Land Use Department
Planning Commission Staff Report

Case No: 2016-107
Hearing Date: November 3, 2016
Applicant: Kevin Juno of Juno Architects for Dan Rowe
Request: Development Plan
Location: 3934 Academy
Case Mgr.: Donna Wynant
Zoning: I-1 PUD
Overlay: None
Pre-app. Mtg.: June 23, 2016
ENN Mtg.: August 29, 2016
Proposal: Mini Self Storage units
Development of 33,850 square feet of new mini storage buildings with a variance request from 14-6.2(D)(3)(e)(ii) Subsections 14-9.2(D)(3), (D)(4) and (D)(8).

<u>Case #2016-107</u>. Airport Mini Storage Units Expansion Development Plan. Juno Architects, agent for Dan Rowe, request approval of a development plan for 33,850 square feet of new mini storage buildings. The property is located at 3934 Academy Road and is zoned I-1 PUD (Light Industrial – Planned Unit Development). The application includes variances to Subsection 14-6.2(D)(3)(e)(ii) Eight-foot masonry wall required abutting residential property line; and Subsections 14-9.2(D)(3), (D)(4) and (D)(8) Street access standards for through streets, connections to the existing road network and cul-de-sacs. (Donna Wynant, Case Manager)

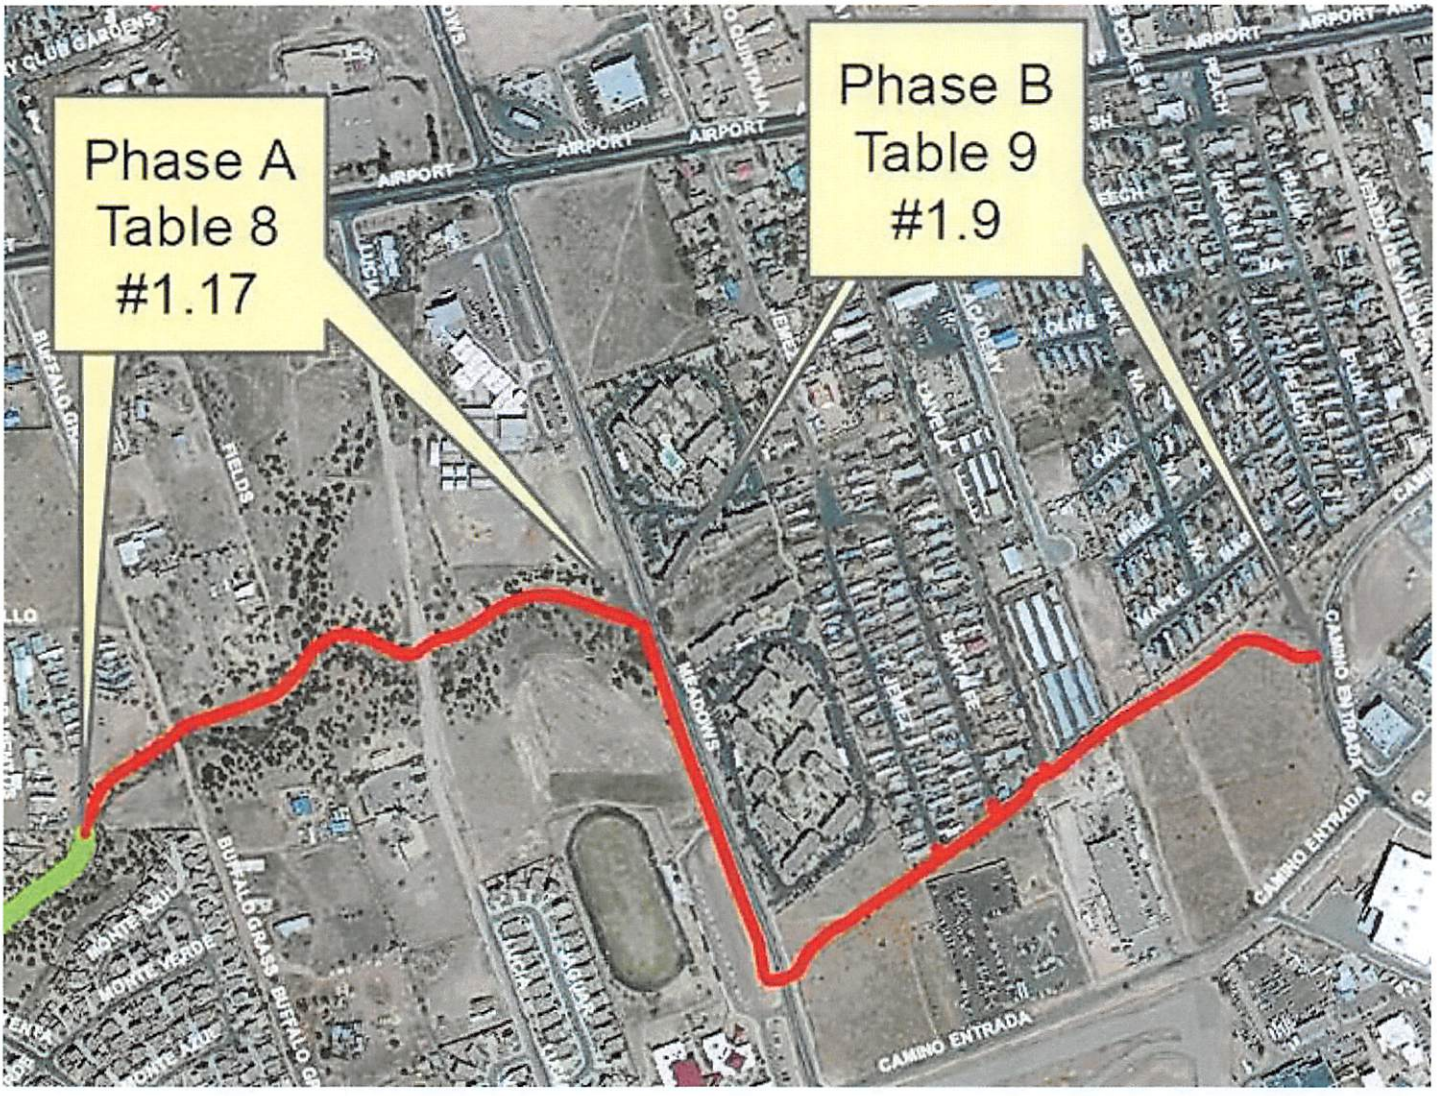
In the Bicycle Master Plan there is a proposed Trail that would run along the southern Boundary of the Airport Road Storage Unit Property. Is there opportunity to obtain easements for future trail connections to connect to Academy and Maple if not also Pine. Based on the proposed design it appears that a connection to Maple may be feasible as this area is shown as Landscaped.
